City of Cannon Beach Tree Removal Application

Project: 3987 S. HEMLOCK, CANNON BEACH

Tree Removal Permit Application Review - 3987 S Hemlock

TREE LOCATION SITE DIAGRAM

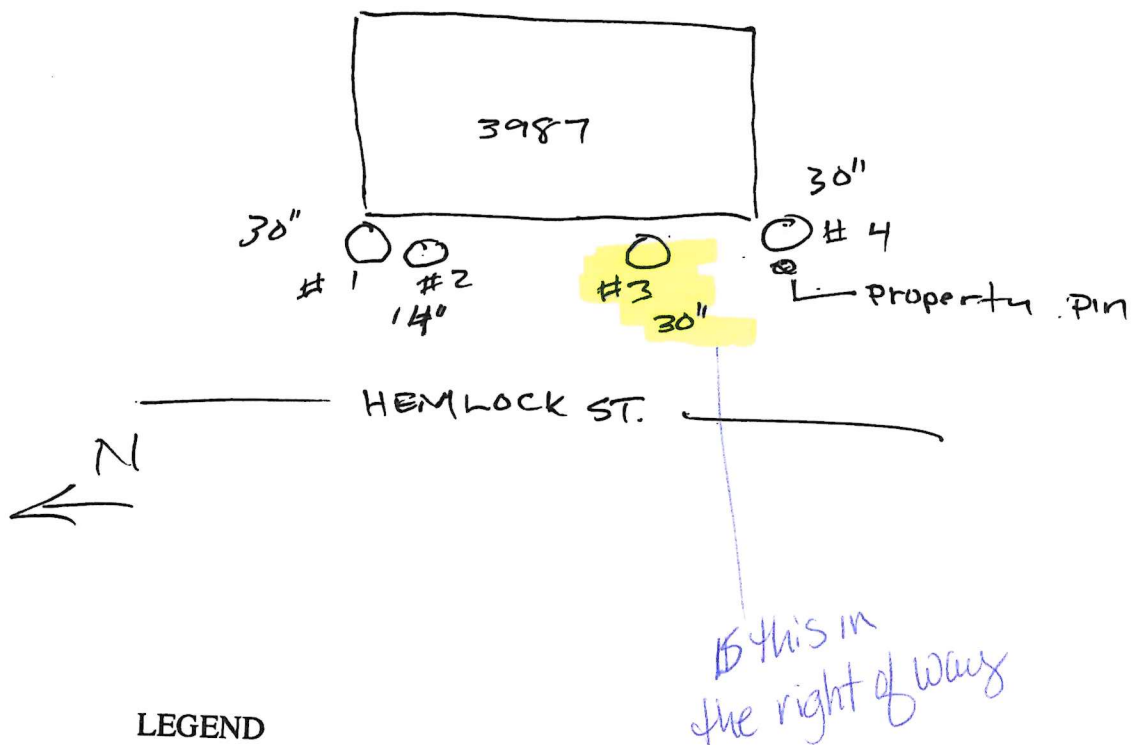
MULTIPLE PRUNING EVENTS FOR POWER LINE CLEARANCE:
 EXCESSIVE CROWN DENSITY OVER NW CORNER OF ROOF, (S-#)
 PROPERTY CORNER STAKE INDICATES TREE (S-#) PARTIAL R-D-1

Recommendations

REVIEW FOR CONSTRUCTION PLAN
